Access Compliance Report

Public Rights-of-Way

Intersection ID: 28615	Main Street: CARDINAL_GLEN_CT	Cross Street: KESTRAL_RIDGE_DR	Location: SW
ADA ID: 5E692E86A327	Ramp Type: PerpDiag	Initial Pass/Fail: Pass	Overall Compliance: No
			Severity Score: 17.75

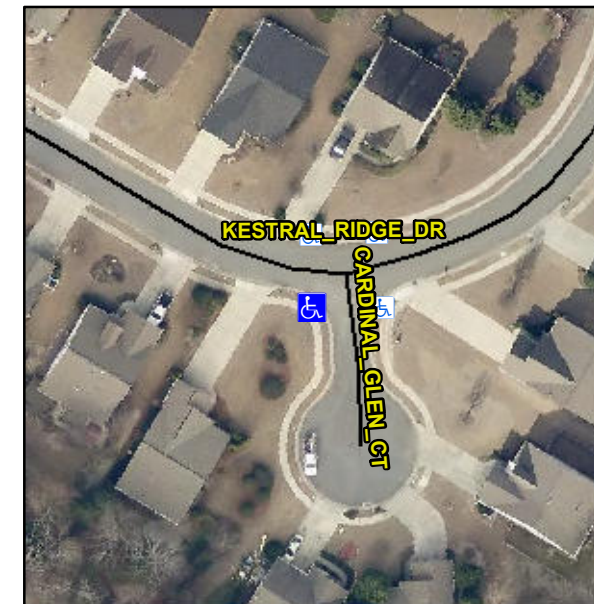
Not Found, R304.2.2, R304.5.3, R304.2.1, R304.2.2-Perp, R304.3.2-Para, R305, R304.5.4

Compliance	Description	Data	Compliance	Description	Data
N/A	Ramp Length (in)	47.0	No	Ramp Slope (%)	8.9
Yes	Ramp Width (in)	85.0	No	Ramp XSlope (%)	5.0
N/A	Flare Type LT	Sloped	N/A	Flare Type RT	N/A
N/A	Flare Slope LT (%)	4.5	N/A	Flare Slope RT (%)	2.4
N/A	Flare Traversable LT?	No	N/A	Flare Traversable RT?	No
No	Landing Length (in)	47.0	No	DWS Provided?	No
Yes	Landing Width (in)	99.0	N/A	DWS Contrast?	No
No	Landing Slope (%)	5.0	N/A	DWS Length (in)	N/A
Yes	Landing X Slope (%)	1.6	N/A	DWS Full Width?	No
N/A	Landing Curb? (Y/N)	No	N/A	DWS Offset (in)	N/A
N/A	Shared Landing?	No			
Yes	Gutter Ponding?	No	No	Gutter Slope (%)	10.2
Yes	Gutter Lip Ht (in)	0.0	Yes	Gutter X Slope (%)	1.9
N/A	Painted X Walk1?	No	N/A	Painted X Walk2?	No
	X Walk 1 Direction	To E		X Walk 2 Direction	To N
N/A	X Walk 1 Width (in)	N/A	N/A	X Walk 2 Width (in)	N/A
	X Walk 1 Slope (%)	1.3		X Walk 2 Slope (%)	2.1
	X Walk 1 X Slope (%)	0.5		X Walk 2 X Slope (%)	0.7

Remove & Replace Curb Ramp With Two New Directional Ramps or Equivalent. Remove & Replace Gutter.
